**MONTGOMERY COUNTY HISTORIC PRESERVATION COMMISSION**  
**STAFF REPORT**

<b>Address:</b>	7411 Piney Branch Ave., Takoma Park	<b>Meeting Date:</b>	10/08/2025
<b>Resource:</b>	Contributing Resource <b>Takoma Park Historic District</b>	<b>Report Date:</b>	9/17/2025
<b>Applicant:</b>	Olive Mueller and Molly Young (Richard J. Vitullo, Architect)	<b>Public Notice:</b>	9/10/2025
<b>Review:</b>	HAWP	<b>Tax Credit:</b>	No
		<b>Staff:</b>	Devon Murtha

**PROPOSAL:** Demolition of screened patio, alterations to an existing rear addition, construction of a new addition, and installation of a rear patio.

**Figure 4: Proposed right side elevation**

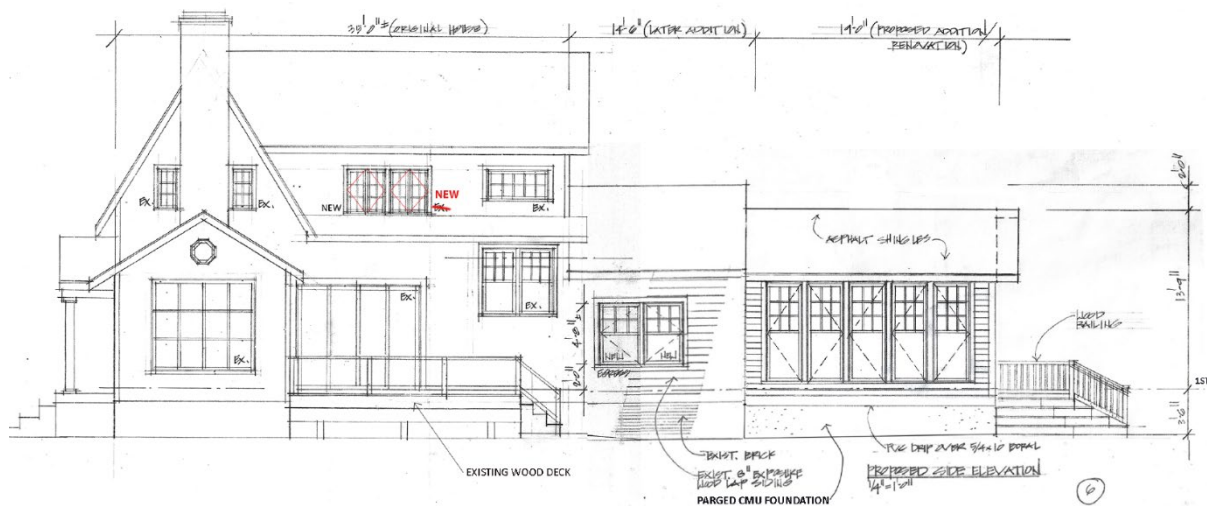
9). Additionally, the proposed fenestration alterations to the right side (south) elevation are obfuscated by the one-story addition to the side of the house and not at all visible from the right-of-way. (Figure 9).

**Figure 5: Proposed left side elevation (left) and rear elevation (right)**

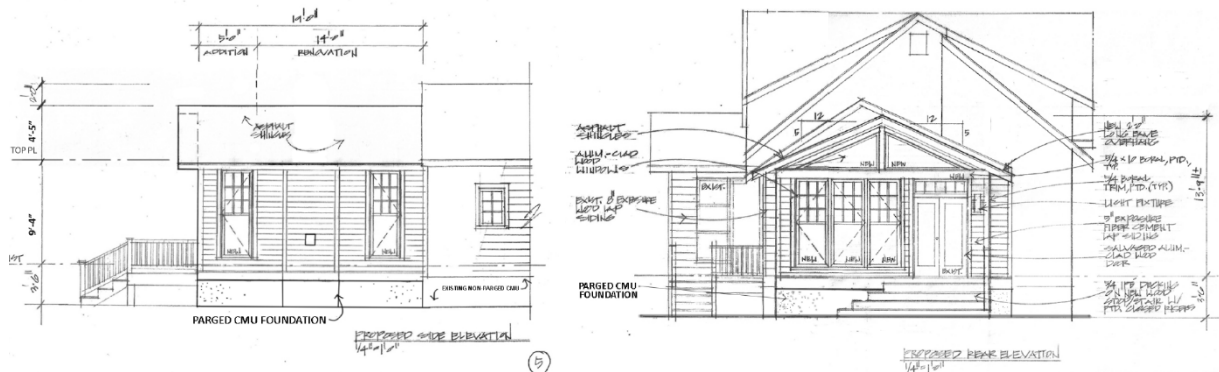
Per *Standard 9*, new work shall be differentiated from the old and shall be compatible with the massing, size, scale, and architectural features to protect the historic integrity of the property and its environment. Staff finds that the massing, size and scale of the addition is appropriate and will have little impact on the resource. The addition is only one story tall and inset from the historic main block, adding to its inconspicuous and deferential profile.

Staff finds that the proposed materials and features are compatible with the resource. The aluminum-clad windows/doors, boral trim, and asphalt shingle roof are consistent with the overall Colonial Revival style of the house. These features are subject to a less rigorous standard of review, as they are minimally visible from the right-of-way and located on non-historic rear additions. The proposed lap siding mirrors the overall appearance of the lap siding on the historic house but is differentiated by its small exposure (5" exposure as opposed to 8"). The fenestration is also consistent with the style of the house, but the substantial glazing also helps to differentiate the proposed addition from the historic main house.

**Figure 7:** Existing drawings for the side elevation of the subject property in 1995 (left) and proposed/as built drawings (right). The areas highlighted in yellow are additions/major alterations that are not original to the house.

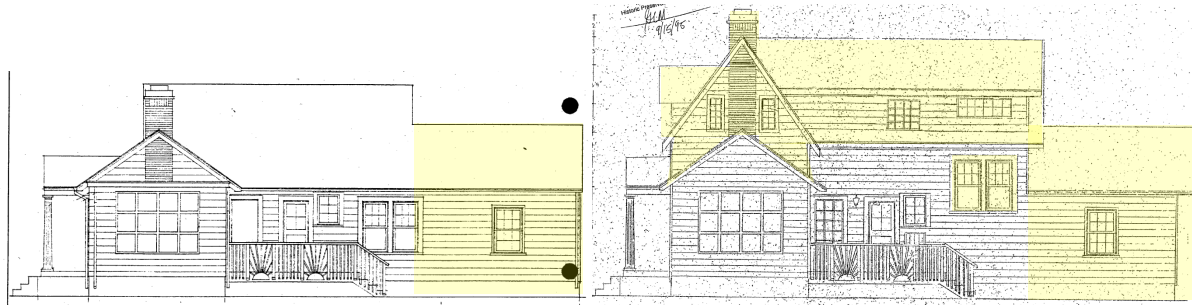
Between 1963 and 1995, the property owner constructed a one-story rear addition to the property. In 1995, the HPC approved a HAWP application to convert the one-and-a-half story house into a two-story house, raising the walls four (4) feet and altering the pitch of the gable roof (*Figure 7*).<sup>2</sup> According to the 1995 HPC Staff report, this renovation also added Colonial Revival elements that gave the house a more consistent architectural appearance. In 2023, the homeowners constructed a screened porch on the rear of the building the property without a HAWP (*Figure 8*). The property has since been sold to new owners.
